Memo to Mr. A. Stermac Date May 17, 1962
Principal Foundation Engineer
Room 107, Lab. Bldg.
From G. C. E. Burkhardt Subject United Counties of Stormont,
Dundas and Glengarry
McGillivray Br. over Raisin Rv.
Lots 13/14 & 38/39
Con. SRR & NRR
Twp. of Charlottenburg

REVIEW OF PRELIMINARY DESIGN

Re: United Counties of Stormont,
Dundas and Glengarry,
McGillivray Br. over Raisin River,
Lots 13/14 & 38/39, Con. SRR & NRR,
Twp. of Charlottenburg. Dist. #9.

HOLE NO. 1

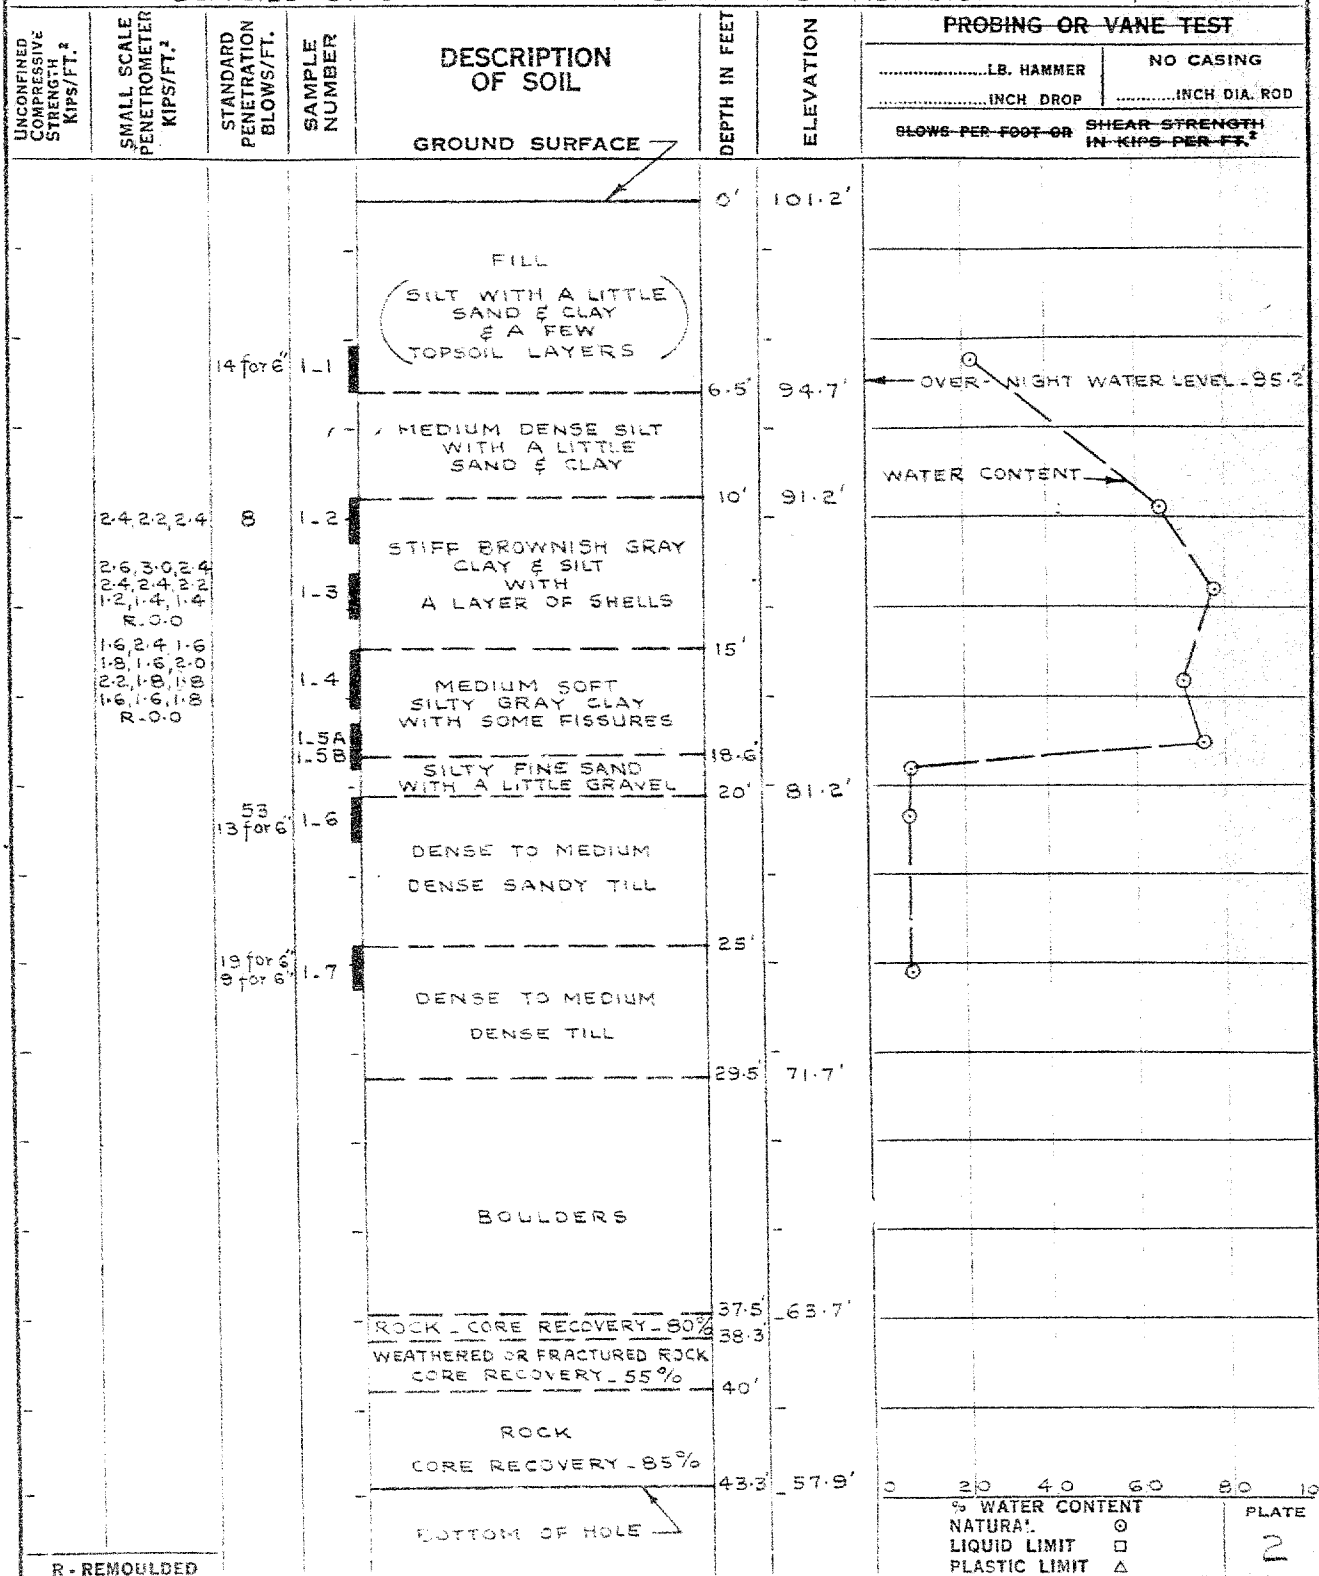
It appears from the report that the recommendation made therein, of using footing foundations for the abutments is based on using shear strength values determined from pocket penetrometer which, at best, can serve no more than a rough guide. Furthermore, the water content of the clay layers in Hole 1, are as high as 70% and settlements contributed from this layer will be appreciable, apart from bearing capacity consideration. Since a dense till stratum exists at approximately 25' depth, we would suggest that all piers and abutments be founded on piles bearing on this stratum. Driving, of course, should be continued until adequate resistance is obtained and a minimum depth of penetration of piles for piers should be governed by scour conditions.

The report on the soils investigation of the above site, has been reviewed and we recommend the abutments to be supported on steel H-piles as for the piers.
